INDESIT company

INC310GAID

Commercial code:

52220a0 Exploded views

0522067: SEALS FOR DOORS FOAMED AS ONE PIECE

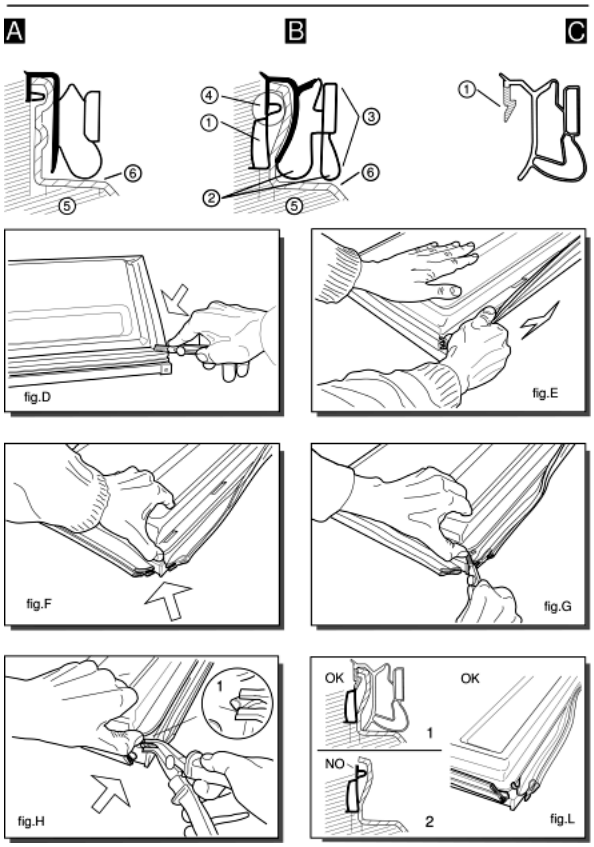
Various types of gaskets with different profile, as shown in figures (A) and (B), are used to fix the door (fig. A-5; B-5) and the inner door (fig. A-6; B-6) on the block foamed doors of combined freezers and refrigerators.
---Ilpea profile 245; 179; 412 (fig.A)
---Ilpea profile 287 (fig.B)
When replacing gaskets with profiles 245; 179; 412 these are fixed with screws (2 per corner) to the door.
Gaskets with profile 287 can not be used as spare parts but are designed to house the Ilpea type 900 gaskets (see figure C).
When replacing the gasket (287), once it is removed you will find a pocket (fig. B-1) between the door and inner door.
The rigid tooth (fig.C-1) of the gasket (900) is inserted inside between the pocket and the inner door, doing away with the need for screws.
Gasket with profile 287 is easy to identify since it has an exterior double edge (fig.B-2) which acts as a cushion when the door is closed.

To replace this gasket, follow these steps:
---Dismount the door and cut the four corners of the gasket along the joint (fig.D);
---lift the gasket and pull it carefully along its full length without tearing it (fig.E).
The purpose here is to detach the inner door slightly from the foam along the exterior edge for a depth equal to that of the gasket (fig.B-3);
---lift the corner of the inner door slightly, prising it up with your thumb (fig.F). Do not use a tool which might break the inner door;
---continue cutting the gasket inside the inner door for about 6 mm (fig.G);
---push in the tip of the pliers (type USAG N131) and pull outwards until you see the top edge of the pocket (fig. B-4) which is empty (fig.H-1);
---if you carry out this operation correctly (fig.L) you will be able to pull off the top edge of the pocket for the full length of the door.
If the gasket tears before the top edge (fig. L-2) you should repeat this operation from the other corner of the door.

---once the gasket (287), has been removed the space above the pocket (fig. L-1) can house the rigid tooth (fig. C-1) of the gasket 900.
When you fit this gasket ensure that it lies flush against the edge for the full length of the door.
If the rigid tooth is difficult to fit, eliminate any residues of foam between the door and the inner door in the gasket area.
fig.5131549A

n1030084: New sliding blocks for fixing the furniture door to the refrigerator door

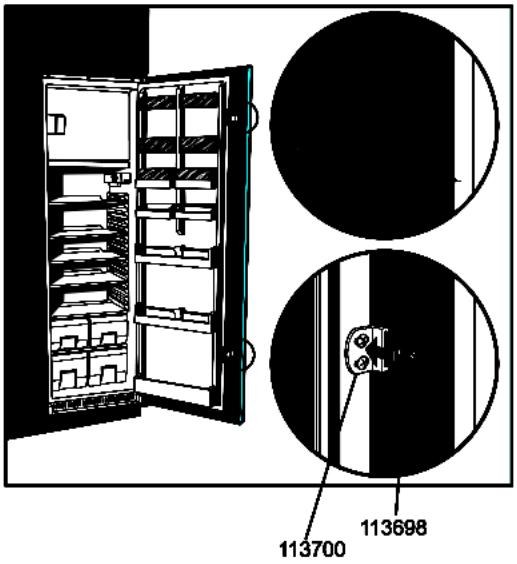
Since October 2004, the Carinaro factory has been using new sliding blocks for fixing the furniture door to the refrigerator door.
The new items are fixed to the side of the refrigerator door, whereas the previous ones were fixed to the front.
The doors are no longer provided with sixteen 2.6 mm holes on the front for fixing the old slides.
The new sliding blocks can also be fitted on premodification models. Proceed as shown in the attached figure (N1030084fig.1).
When replacing the sliding blocks on premodification models it will necessary to replace both guides.
This modification has involved changing the installation KITS

New parts

113698 - LARGE NYLON HOLDER SLIDE
113700 - NYLON HOLDER SLIDING GUIDE

Installation kit (models with plastic slides)

C00113967 - REFRIGERATOR INSTALLATION KIT INC. 2/P 290L (10/2004)
C00113968 - REFRIGERATOR INSTALLATION KIT INC. 2/P 290L (10/2004)
C00113970 - REFRIGERATOR INSTALLATION KIT INC. 2/P 240L (10/2004)
C00113971 - FREEZER INSTALLATION KIT INC 1/P 200L (10/2004)
C00113973 - FREEZER INSTALLATION KIT INC 1/P 140L (10/2004)
C00113974 - REFRIGERATOR INSTALLATION KIT INC. 1/P 130L 10/2004)
C00113975 - FREEZER INSTALLATION KIT INC. 2/P 300/330L (10/2004)
C00113977 - REFRIGERATOR INSTALLATION KIT INC.1/P 230L (10/2004)
C00113979 - REFRIGERATOR INSTALLATION KIT INC.1/P 160L (10/2004)
C00113985 - FREEZER INSTALLATION KIT INC 2/P 300L (10/2004)
C00113986 - FREEZER INSTALLATION KIT INC 2/P 300L (10/2004)
C00113987 - FREEZER INSTALLATION KIT INC 2/P 240L (10/2004)
C00113988 - REFRIGERATOR INSTALLATION KIT INC.1/P 300L (10/2004)
C00113989 - REFRIGERATOR INSTALLATION KIT INC.1/P 300L (10/2004)
